**From:** [REDACTED]  
**Sent:** 19 February 2024 15:54  
**To:** [REDACTED]  
**Subject:** FW: Roman Roads Research Association report regarding DOV/23/01363 Goshall Valley, East Street, Ash  
**Attachments:** SR011-richborough-little\_south\_solar\_farm-Haken\_2024.pdf

## ASSESSMENT OF THE PROBABLE ROMAN ROAD NETWORK IN THE VICINITY OF THE PROPOSED LITTLE SOUTH SOLAR FARM, ASH

SITE REPORT NO. SR011

Figure 1. Map showing the probable layout of Roman roads near Richborough. Roads previously suggested but which have no tangible evidence for their existence or do not conform with typical Roman road planning are not marked.

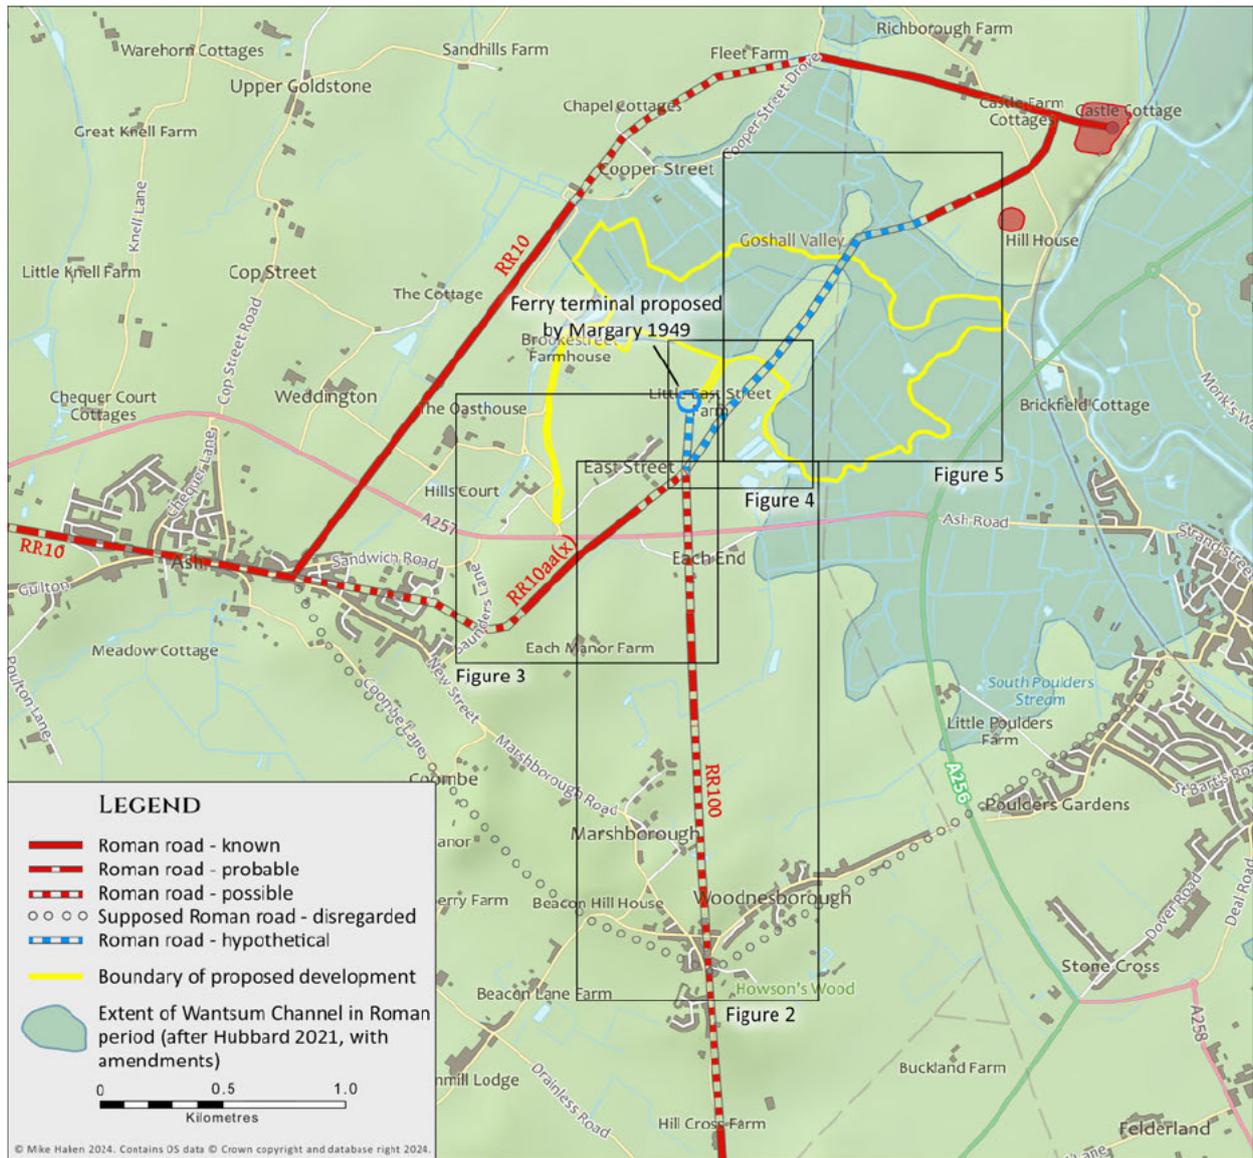
- The AIA’s map of Historic Environment Data shows Roman roads in the area which are actually mainly speculative but this is not made clear (Foundations Heritage 2023, fig. 2.2).

- In assessing the possibility of a Roman road crossing the site, the AIA has focused too heavily on a lack of known evidence from the site itself, and is not thorough in its assessment of the surrounding Roman road network in order to accurately place the site in the context of that network.

- With reference to the above point, The AIA map (fig. 2.2) omits a vital segment of road that is known for certain to exist, specifically, the road that runs through the extra-mural settlement (often termed *vicus*) at *Rutupiae* and swings southwestwards past the amphitheatre to the edge of the Wantsum Channel, a road that is vital to the correct understanding of the road across the site (fig. 1). Its identification close to the Wantsum Channel during excavation in 2007 is mentioned (para 6.4.5) but the significance not recognised and it is not mapped.

The roads for which there is sound evidence are illustrated in figure 1. and described below. The numbers used to refer to individual roads are those awarded by I.D.Margary (1955), with the alternative route of RR10aa added by the RRRRA and distinguished by a (x) suffix. The status ratings of known, probable & possible have been determined according to protocols based on those used by the Welsh archaeological trusts and more recently refined by Haken (2021).

**Figure 2.** Lidar visualisation clearly showing the agger of part of the extension of RR10 towards East Street and a junction with RR100 from Dover

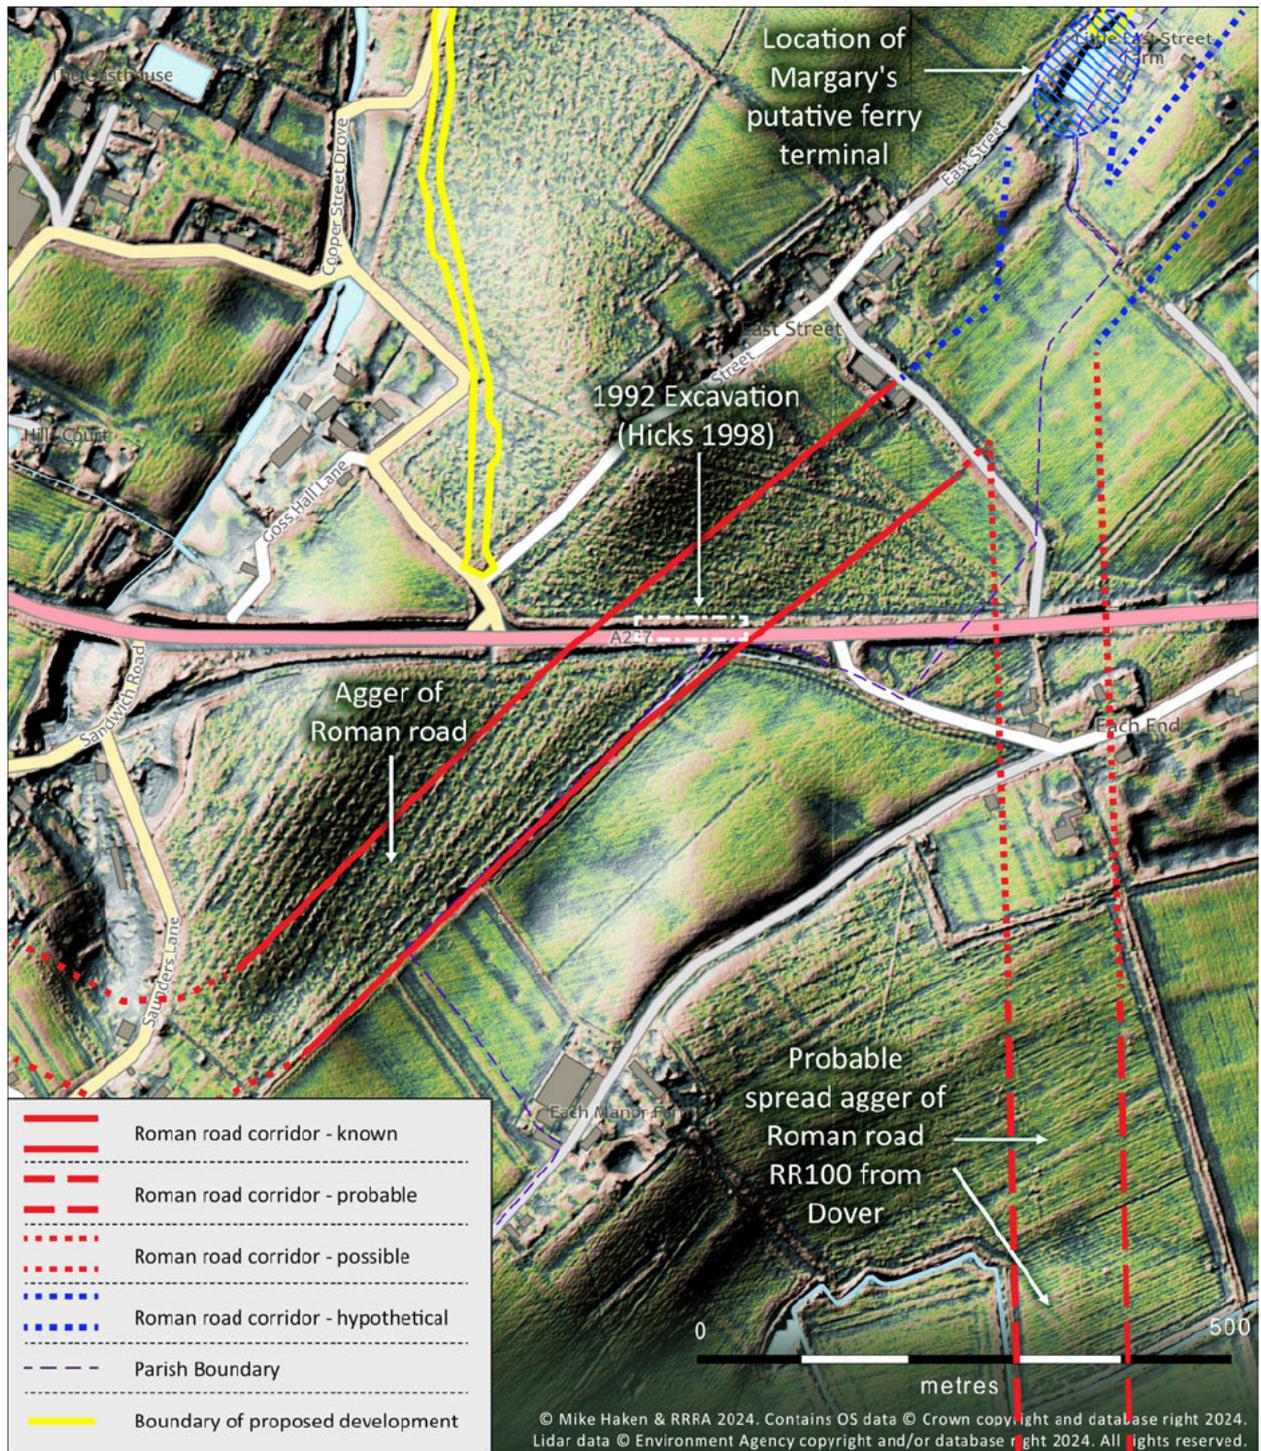
The remains of the road can be seen on lidar imagery running for 830m from East Street at TR30625869 to about TR30005815 near Saunders Lane, where all trace is lost, however it is presumed that it skirted around the head of the small valley west of the lane (thus avoiding gradients of 1 in 5), where it would meet the extended alignment of RR10 from Ash to Wenderton Lane already described. This is essentially a similar conclusion reached by the excavation report, although they were unaware that this road extended as far southwest as it does and of the true course of RR10 west of Ash.

To the northeast, it is clear that RR100 from Dover (see fig. 3 & 2.5) meets this road near East Street, although what happens beyond that junction is less clear. The excavation report did recognise that this road was aligned on Richborough, and that this was the likely destination, concluding that it 'seems probable that the Wantsum channel was crossed by ferry' (Hicks 1998, 102). However, no evidence was presented to justify such a conclusion, nor were any similar examples of wetland crossings by causeway or bridge discussed. Instead, Margary's speculative suggestion of a ferry terminal near Little East Street Farm (1949, 132) which Margary himself appears to have later rejected (see this report, 2) was suggested as a destination, and this view has been repeated in the AIA. This issue is discussed in detail later in this report.

Figure 3. Lidar visualisation showing evidence for RR100 north of Woodnesborough on the alignment from Dover

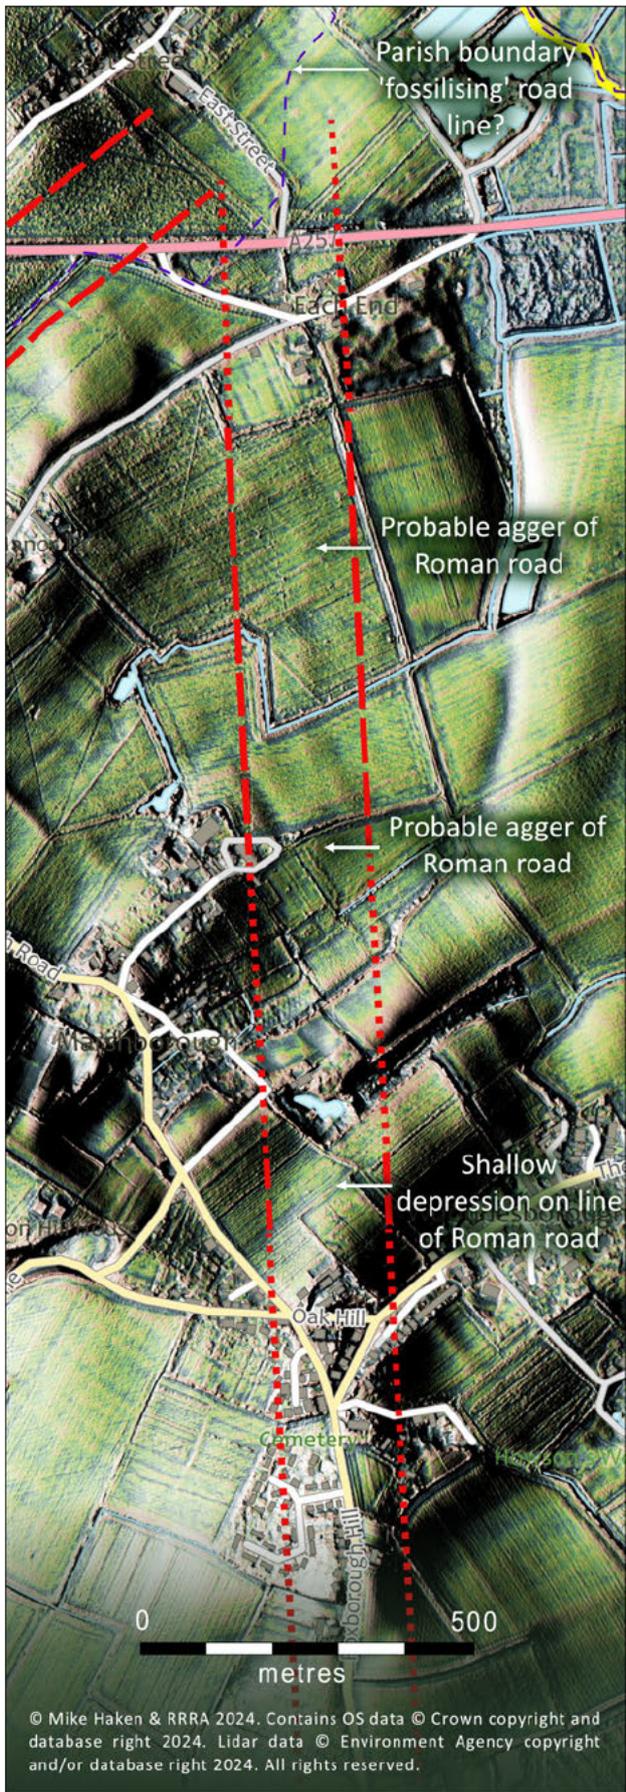
Analysis of lidar carried out for this report suggests that Phillips was at least half right, since a series of linear features following the Dover alignment can clearly be seen between Woodnesborough and Each End, where it is met by another road approaching from the southwest (see para. 2.5). A very faint feature along this alignment just north of Woodnesborough can just be seen as a very shallow depression about 15m across, perhaps suggesting that the metalling has been robbed out. The northern group of features all present as a very low ridge about 25m across, exactly what should be expected for the agger of a Roman road heavily truncated by modern ploughing. That said, there remains the very slim possibility that the truncated features represent a different monument type, hence the rating of probable. Interestingly, a short length of the Ash/Woodnesborough parish boundary seems to have fossilised the position of the road junction, and could perhaps help confirm that the road from the junction to Ash went out of use in the late 3<sup>rd</sup> century, as the excavation results suggested, after which the junction effectively became a bend in the Dover road.

**Figure 4.** Lidar visualisation of the area around Little East Street Farm, and the location of Margary's putative ferry.

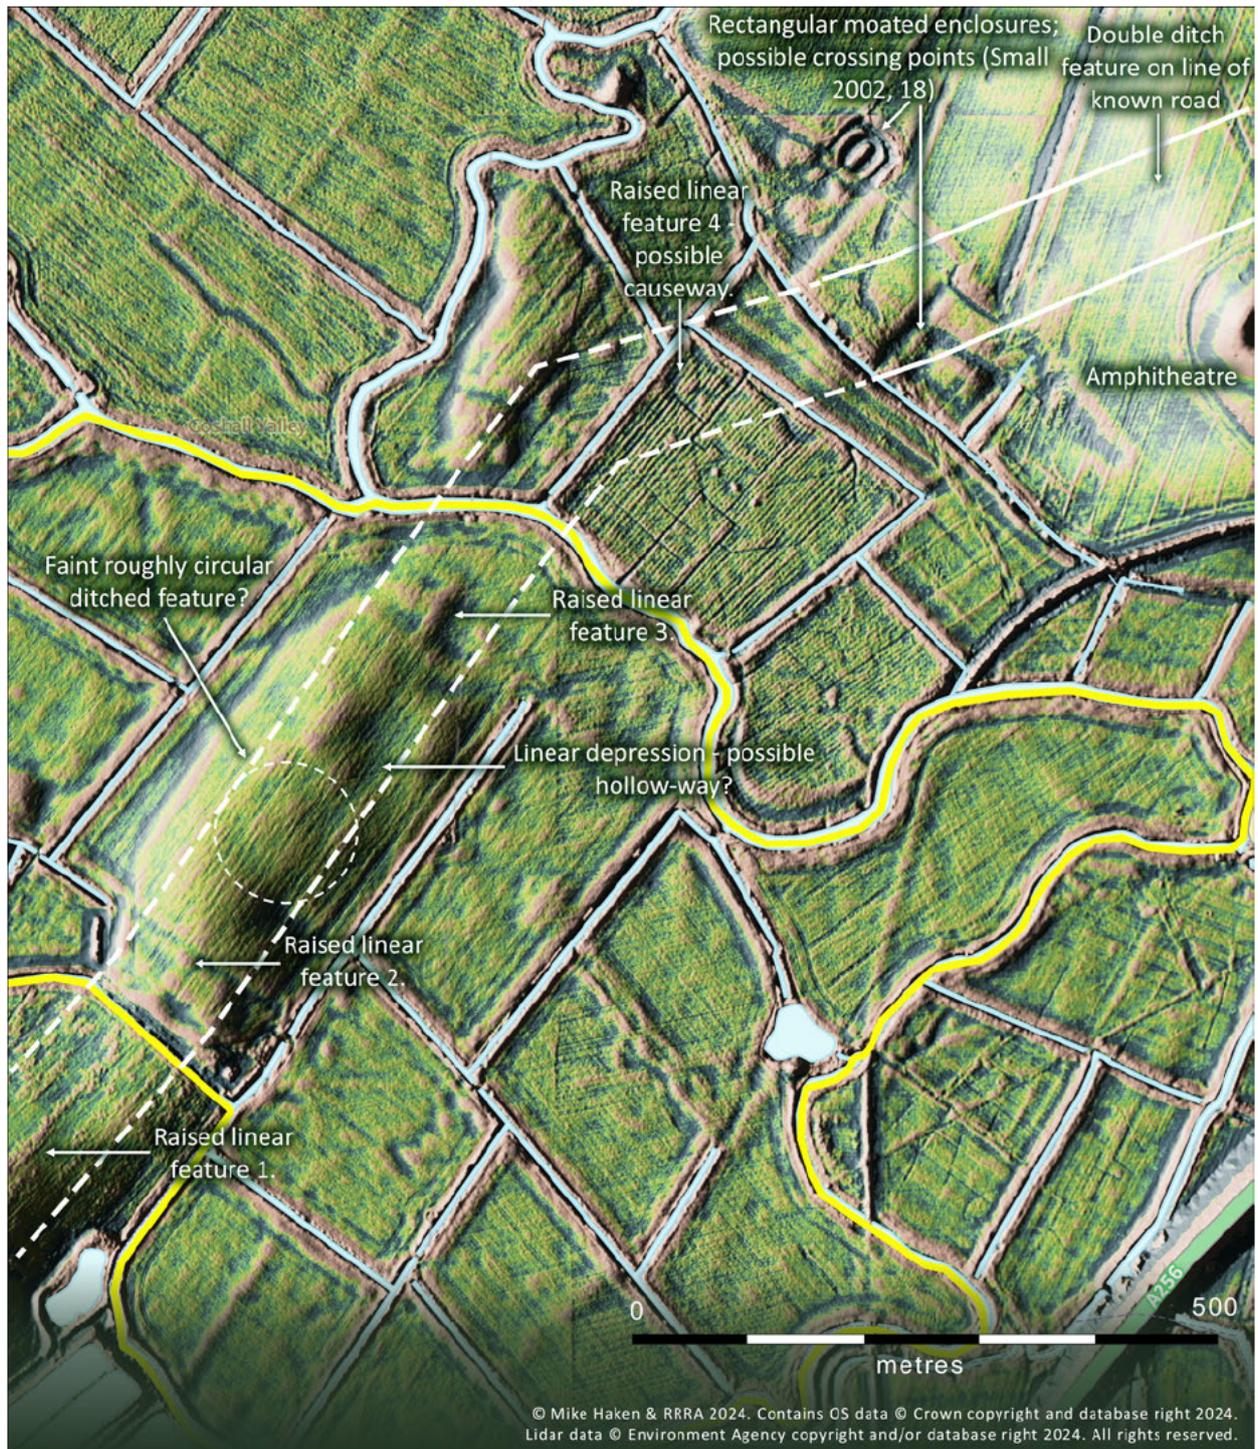
Figure 4 shows the area around Little East Street Farm, where Margary originally located his supposed ferry terminal. Unfortunately the AIA authors conflated the excavated road approaching from the south west with the road Margary describes approaching the supposed terminal from the south (Foundations Heritage 2023, 6.4.10 (p.25)), which is of course the road from Dover - there are two roads, not one. Margary noted that 'an inlet still exists at this place, ending in a rectangular basin still holding water, situated just at the end of the alignment of the Dover road'. This still survives (see fig. 4), although whether or not this was ever a part of a ferry terminal is unknown. The AIA authors concluded that the rectangular basin is probably post-medieval (op. cit.), with no obvious signs of Roman work being visible. Of course, it always possible that the surviving 'basin' and the channel leading to it are relatively modern re-cuts of a Roman feature, however without excavation that can never be established one way or the other. Unfortunately, whilst recognising the possibility of a Roman ferry terminal at this point, there is no recognition of the fact in the AIA that a proposed access road is

scheduled to run along the course of Margary’s inlet, with no recommendations for investigations or mitigation nor any reference to potential damage to what would be a nationally important archaeological site. The EIA (Stantec 2023) also appears to ignore this completely.

Rather than the 'Slope' visualisation used in the Geophysical Survey Report which resulted in no potential archaeology on the ridge, processing using Local Relief Model overlaid on Hillshade results in a quite different picture emerging. Fig. 5 shows a lidar visualisation of the mound and its surroundings which exhibit evidence of man made features, potentially archaeological in nature which apart from one broadly fit into four categories; former boundary features, multiple small depressions of unknown date indicative of gravel quarrying, linear features orientated lengthways along the mound (marked as Raised linear features 1-3 on fig. 5). The exception is a faint roughly circular feature some 70m in diameter. Whilst this may represent a series of gravel extraction pits forming a circle purely by chance, it could equally be more significant, perhaps taking advantage of the position within the marsh.

Raised Linear Feature 1 (see fig.5) is a straight but poorly defined linear feature just outside the proposed development. Whilst roughly in the right place for the putative road, it could also represent a former enclosure boundary, or perhaps a later boundary following the line of the road, although no such boundary is marked on any extant maps. More interesting are Raised Linears 2 & 3 which align perfectly with each other at either end of the gravel mound. Linear 2 is cut by two ditches, both probably field boundary features, and therefore probably predates the boundary in that position marked on the Gouge map of 1823-5 (Foundations Heritage 2023, fig. 3.1). It appears to be leading onto the mound and could potentially be part of a road, or equally have simply given access for gravel extraction. A similar feature at the northern end (Raised Linear Feature 3) is slightly different since it appears to cross two ditches (where there was also a field boundary marked on the Gouge map). This does not mean that it necessarily post-dates them, since it could have been reinstated later in the 19<sup>th</sup> century to give access to the mound for gravel extraction. To the southeast of the line between Raised Linear Features 2 & 3 and parallel to them is a straight linear depression running along the mound, potentially a hollow-way. Whilst it is impossible to ascribe a date to this feature, it remains conceivable that it developed parallel to a former road that had ceased to be maintained. Without intrusive investigation it is impossible to be certain of the true nature of these features, but it is clearly incorrect to conclude that there is 'no evidence for earthworks that could relate to features like a Roman road' (Roseveare 2023, 3)

Figure 6. Geological map clearly illustrating the most logical route for a Roman road approaching from the south to cross the Wantsum Channel

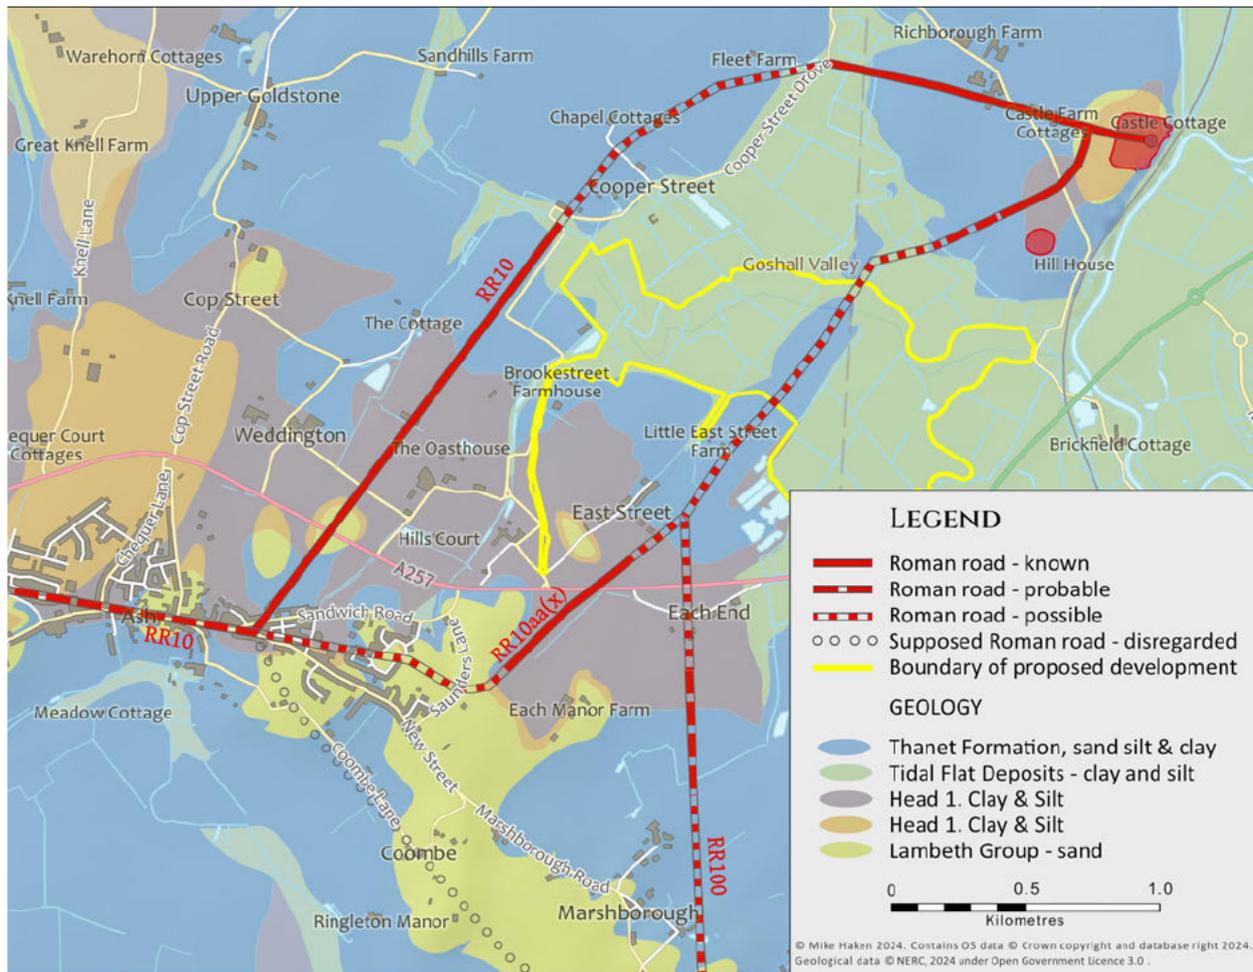
extremely well on modern geological maps as illustrated in figure 6 where it can be seen in blue standing proud of the Tidal Flat Deposits of the Wantsum Channel (green). The most probable crossing point is from somewhere close to Raised Linear Feature 3 (fig. 5), although in order reach this, it seems probable that a short length of piled causeway would have been needed across the low ground at the southern end of the mound, a short length of which is within the proposed site, cut by a modern drainage ditch.

A direct crossing from the north end of the mound to the north bank is about 400m. With the much reduced distance, a ferry now becomes a viable option, especially as there are two rectangular features on the northern bank which have been interpreted as possible landing or beaching sites. Instead of a ferry, could a bridge have been possible? A direct bridge (not considered in the AIA) would have been about 400m long, although this could have been reduced by using an indirect route utilising the smaller gravel mound to the north, thus needing two bridges of about 150m and 180m in length. Both suggestions are technologically possible; by way of example, a century before the Claudian invasion, Caesar's legions took just ten days to bridge the Rhine (*de Bello Gallico* 4.17-19), probably near Andernach, with a structure between 250m and 350m in length. However, such a bridge would probably prevent access to the anchorage to the northwest by seagoing vessels with fixed masts. Therefore, if such an anchorage existed, whether a bridge was used comes down to whether ships needed to get through, and since the northern channel near Fleet Farm could well have been open, a bridge has to be a possibility. Even if a ferry were used (assuming six boats), the journey time to Dover from the west gate of Richborough to Woodnesborough is only three minutes slower using the ferry than skirting round via RR10Ash. Clearly, there was never any compelling reason for the Roman Army to build a road
